**NATIONAL FLOOD INSURANCE PROGRAM, LEVEE SYSTEM
EVALUATION REPORT (NLSE) FOR TRES RIOS NORTH LEVEE,
MARICOPA COUNTY, ARIZONA**

by
US Army Corps of Engineers
Los Angeles District, Geotechnical Branch
915 Wilshire Boulevard, Los Angeles CA 90017
November 2012

I am pleased to submit to you the Los Angeles District's final National Flood Insurance Program (NFIP) Levee System Evaluation Report (NLSER) for the Tres Rios North Levee Phase 1A and Phase 1B. This report concludes that the Tres Rios North Levee Phase 1A and Phase 1B have met all of the requirements established by USACE for determining that the levee system can be reasonably expected to exclude the 1% annual chance exceedance flood, also referred to as the base flood, from the leveed area. This NLSER documents the NFIP levee system evaluation requirements, assumptions made, and analyses conducted to make this NFIP levee system evaluation finding and that they are consistent with requirements outlined in Title 44 of the Code of Federal Regulations, Section 65.10 (44 CFR 65.10), *Mapping Areas Protected by Levee Systems*.

FIGURE 1

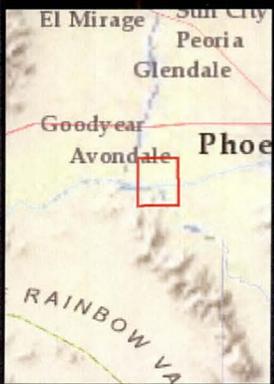
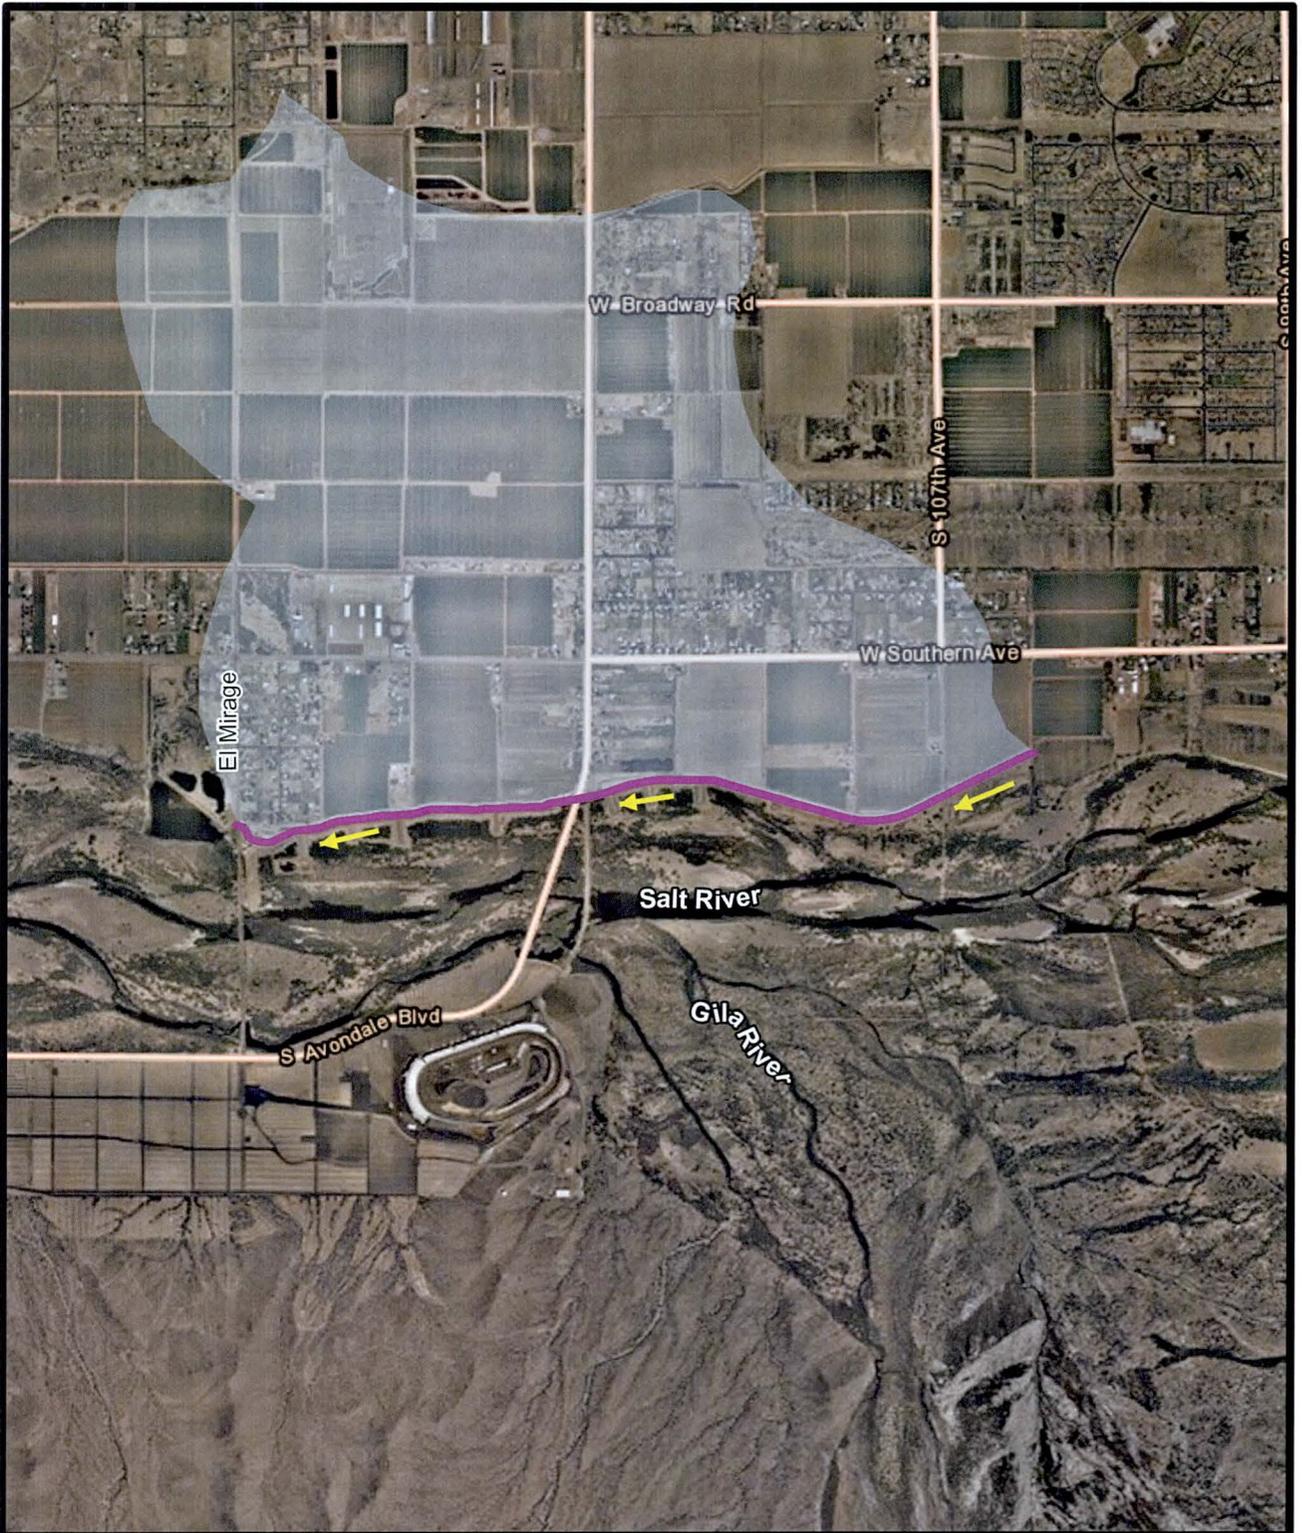
The legend title falls over the aerial photograph (it does not appear to lie within the legend box). Please label this as Figure 1 to keep in context with the text.

FIGURE 2

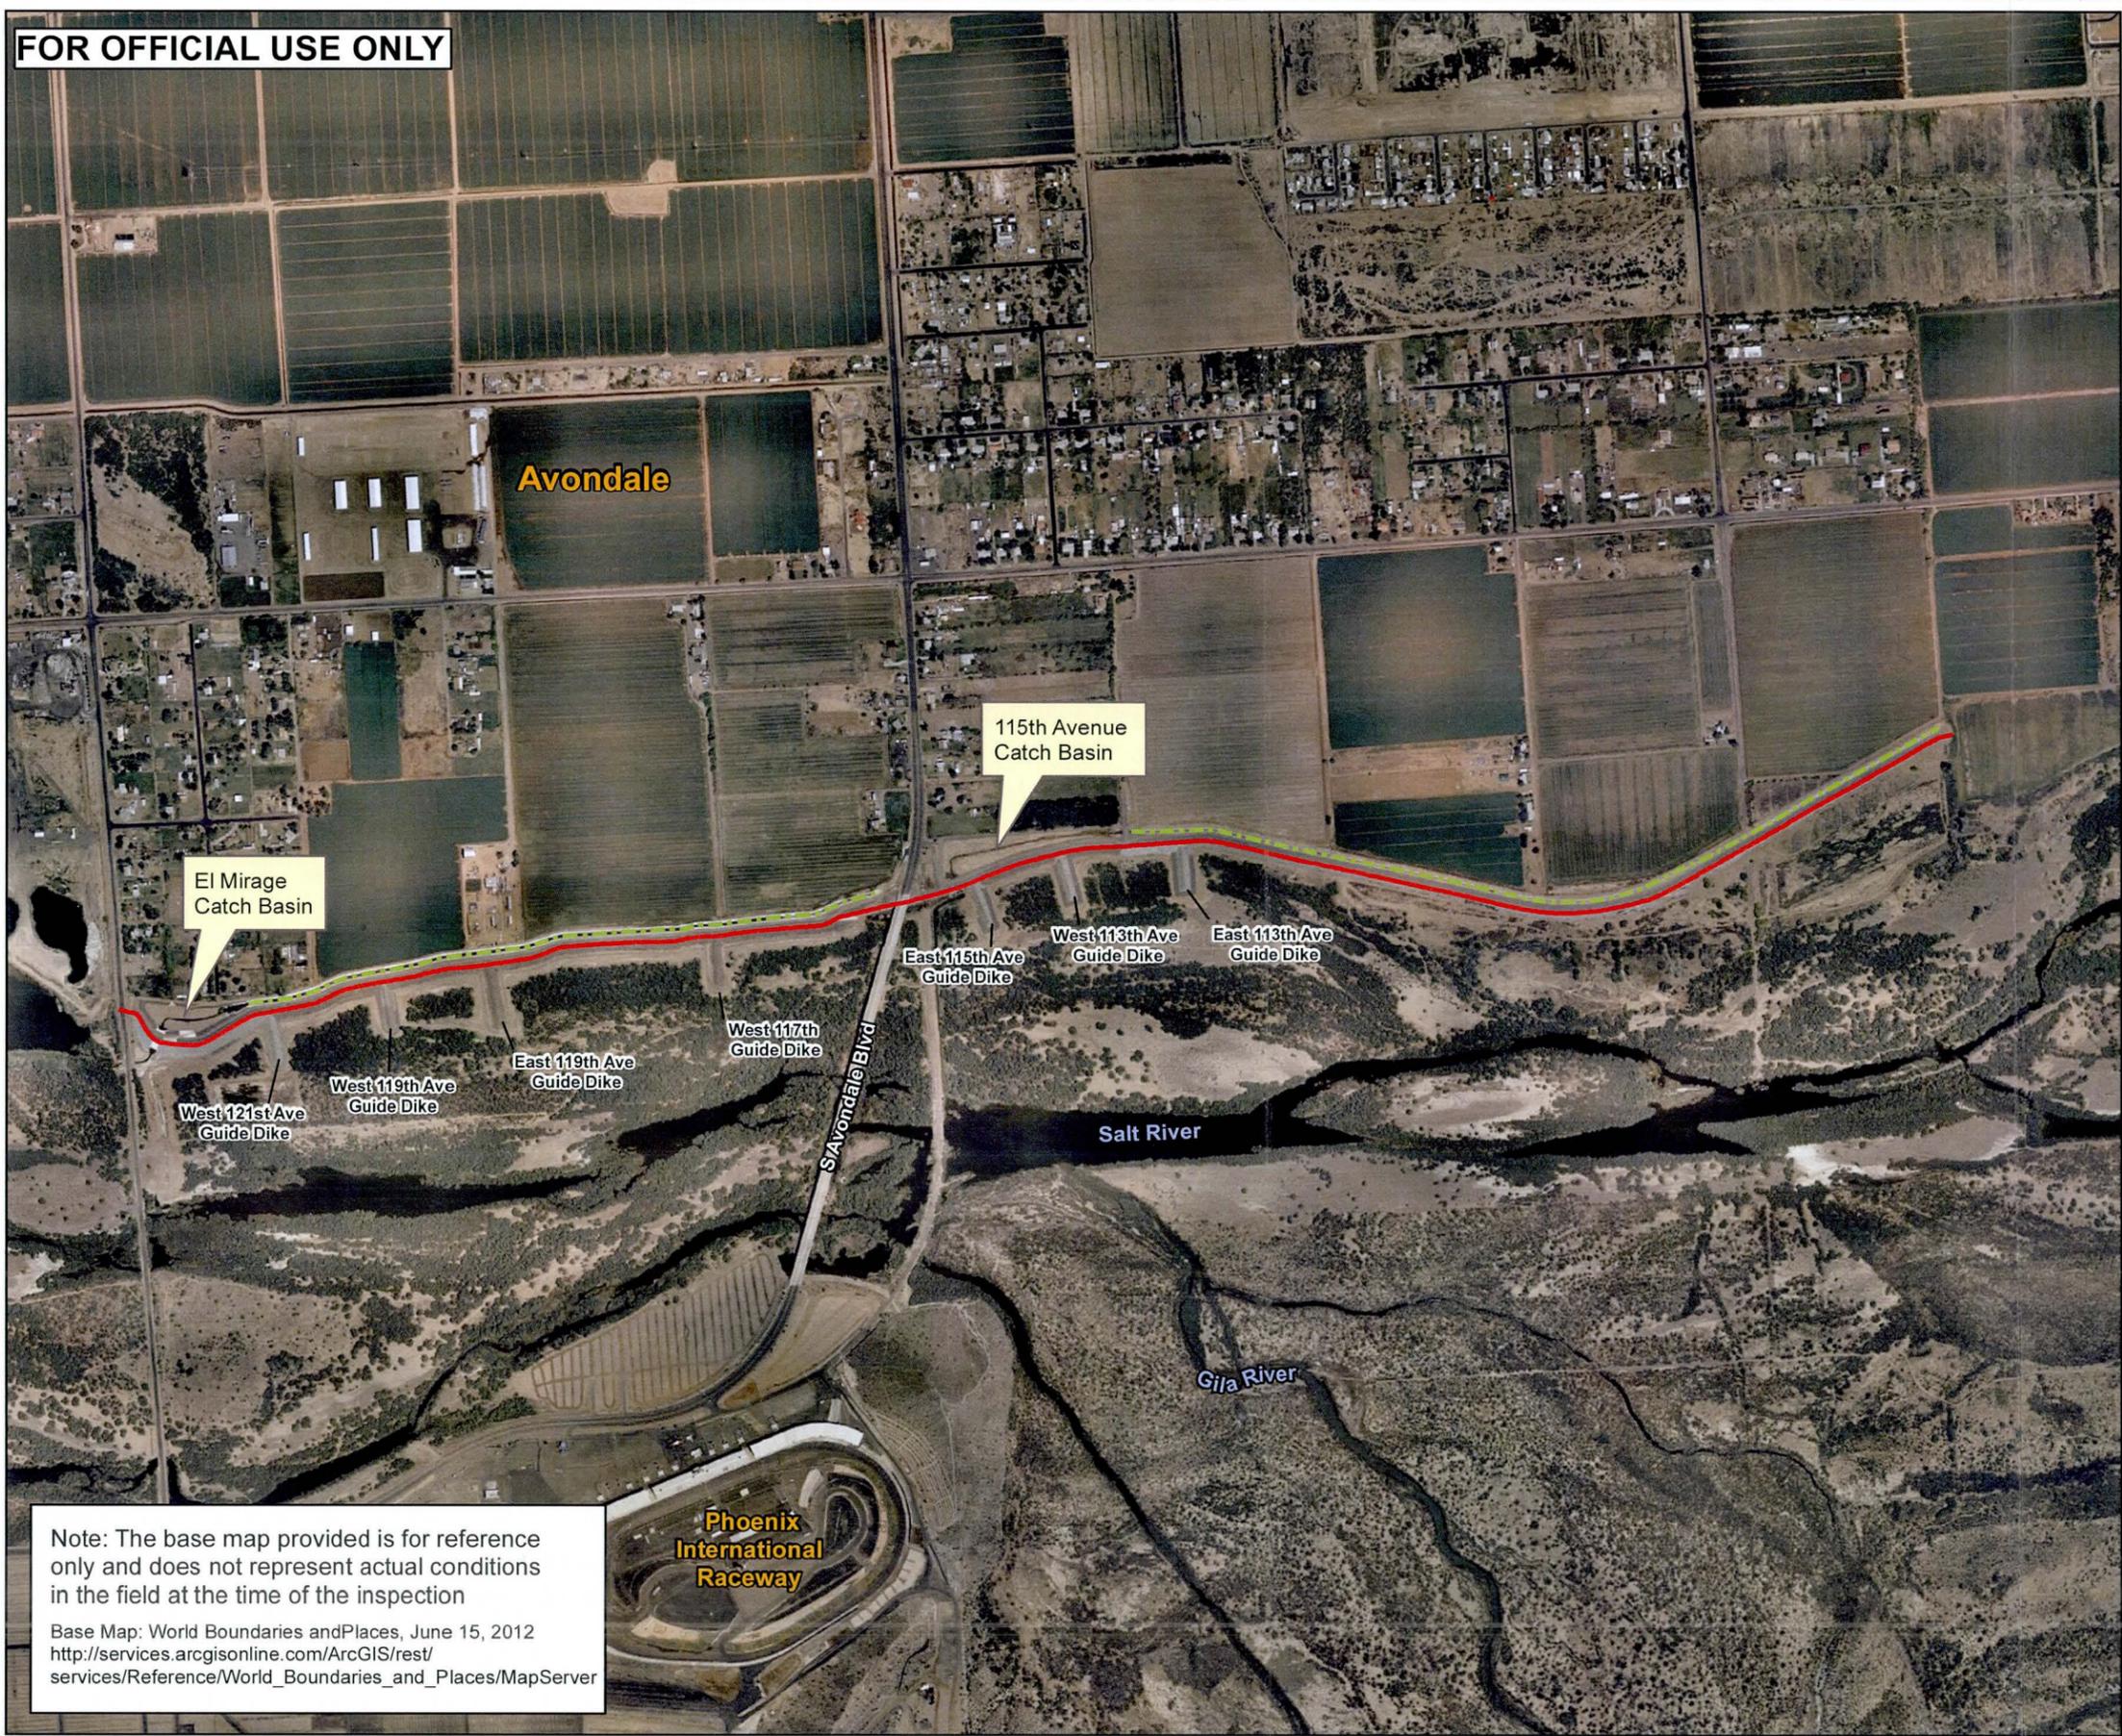
What is the definition of "leveed area"? From Figure 2, it appears to be the area protected by the levee, but it is not clear.

The "leveed area" shown is greater than the effects of the levee on flood protection. To be in conformance with the study results, please consider: West of El Mirage Rd. the area should not extend north of Broadway Rd.; it should not extend north of Broadway Rd. east of 118th avenue (the floodplain shown in this area is not from the Gila River - it is from a different flooding source). Also, please label this Figure 2 to keep in context with the foregoing text.

The following clarification has been added to the text: Figure 2 presents the Leveed Area as shown on the National Levee Database. This area should not be confused with a flood plain, but is used in a nation-wide comparison of relative potential consequences behind levees. The leveed area consists of elevations lower than the top of levee, but does not take into account the general direction of overland flow. It represents the "bath tub affect" of a levee and is determined by projecting horizontal lines from the top of the levee to points of equal elevation.
